INDESIT company

Model type:
AVSD129EU

Commercial code:
F029989

n1040325: New shock absorber fixing system with pin

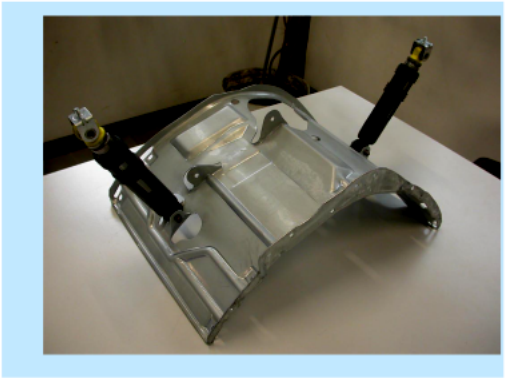
From serial no. 40427.0001, shock absorbers have been fixed to the tank unit cradle with two 11 mm pins code C00110163 (see fig. 01 and 02 enclosed) in place of the 8 mm screws code 093750 and relevant locking nuts code 030443, on all washing

machines and dryers produced in the Comunanza factory.
The items affected by this modification are:
1) The cradles have the same Service code, as they can be used in place of the new ones after widening the shock absorber fixing holes to a diameter of 10 mm.
Code 093848 - Tank unit cradle 46 lt
Code 093878 - Tank unit cradle 40 lt.
2) The new shock absorbers, with fixing bushing having no s/steel spacer, are not managed as they are interchangeable with the premodified items (make sure they are CIMA type, as the managed items), fixed with M8 screws code 093750 and related locking nut code 030443 (see figs. 05 and 06).
Code 093884 - Shock absorber 80 N
Code 093885 - Shock absorber 100 N

To remove the shock absorber from the tank, first extract the pin with a few hammer taps (see fig.03) until it is aligned with the tank bracket and then pull it out with a pair of pliers (see fig. 04).
(To refit the shock absorber use a new pin. Insert the pin until the toroidal edge is aligned with the bracket.)

n1040326: Two-bearing mechanism on Slim range washing machines

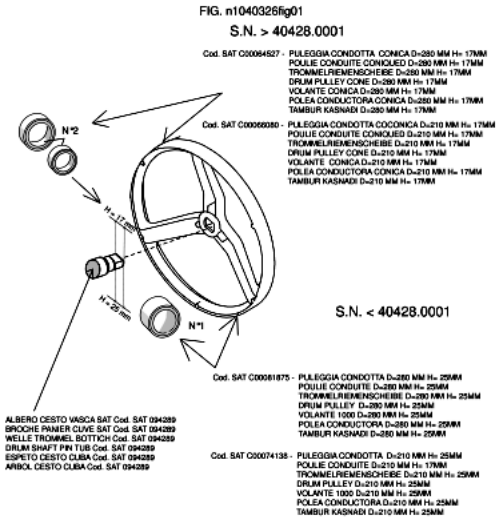
From serial no. 40428.0001, all Slim range models produced in the Comunanza factory have been equipped with a two-bearing mechanism in place of the single-bearing one.

The Service codes of the new mechanism are:
Service code C00096186 - SEAL RING CV4;
Service code C00002591 - BEARING 20X47X14 6204 SKF;
Service code C00013563 - BEARING 25 X52 X 15 6205 - 2Z SKF;
Service code C00110340 - CROSS WITH SEAL RING (2C) SNELLA;
Service code C00094289 - EVO 40L TANK SLIM (1-C) > (2-C)EVOII;
Service code C00094290 - OUTER- SET 40 L.(1-C)>(2-C)EVOII;
Service code C00064527 - DRIVEN PULLEY CONE D=280 MM H= 17MM;
Service code C00066080 - DRIVEN PULLEY CONE D= 210 MM H=17 MM.

The tank assembly with the new two-bearing cross has the same Service code as the single-bearing one (C00094289); the latter will be available until stocks run out.
When replacing the tank, make sure that the value H (17 mm or 25 mm) of the basket cross shaft corresponds to the value H of the pulley (see Fig.001).

The following premodified items will continue to be used:
Service code C00026298 - BEARING BA2B 633667 30X60.03X37;
Service code C00039667 - SEAL RING;
Service code C00074137 - CROSS WITH SEAL RING;
Service code C00081875 - DRIVEN PULLEY D=280MM H=25MM;
Service code C00074138 - DRIVEN PULLEY D = 210MM H=25MM;
Service code C00026299 - SEEGER RING SB 60X1,5.

Fig . 001

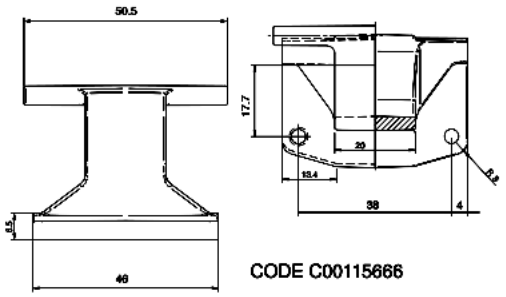
n1040353: Introduction of 150° Zamac hinge on Ariston models (Comunanza).

From serial no. 50207.0001, all Ariston models produced in the Comunanza factory (see table 001 attached) with industrial code (given on the rating plate) starting with 80, have been equipped with a Zamac hinge with 150° opening angle, code C00115666 (see Fig.001).
This modification has involved the introduction of the following items:

Code C00115670 - Complete door EVOII 150° white 27 with standard glass;
Code C00115674 - Complete door EVOII 150° white 27 with long glass;
Code C00115668 - Complete door EVOII 150° silver with standard glass;
Code C00115673 - Complete door EVOII 150° silver snella standard glass;
Code C00115662 - EVOII body for 150° hinge white 27
Code C00115663 - EVOII body for 150° hinge silver 27
Code C00115664 - Snella EVOII body for 150° hinge white 27
Code C00115665 - Snella EVOII body for 150° hinge silver

The premodified items are not interchangeable separately with the modified ones.

Fig . 001

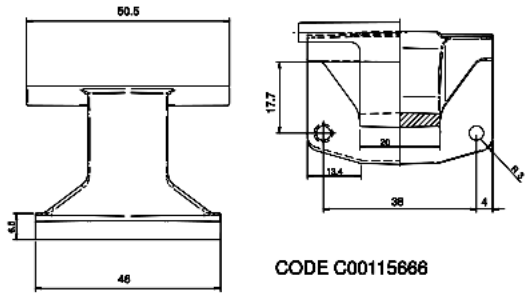
n1040359: Polar White Factory 80 (Comunanza)

From serial no. 50315.0001, the new "Polar White" colour is used on all washing machines and washer-dryers produced in factory 80 in place of White 27.
The third last number of the Industrial Code given on the rating plate of the modified models is 9 (e.g. 80286390900).

To determine the new Polar White codes, it is necessary to know the industrial code or serial number of the appliance being repaired.
The new items, which bear the initials "PW" in place of "B27", are not aesthetically interchangeable with premodification items as the whites are different. Both colours will be available for some time.
The items affected by this modification are:
Body, rear panel, top, control panel, handles, buttons, knobs, knob disc, door and plinth.
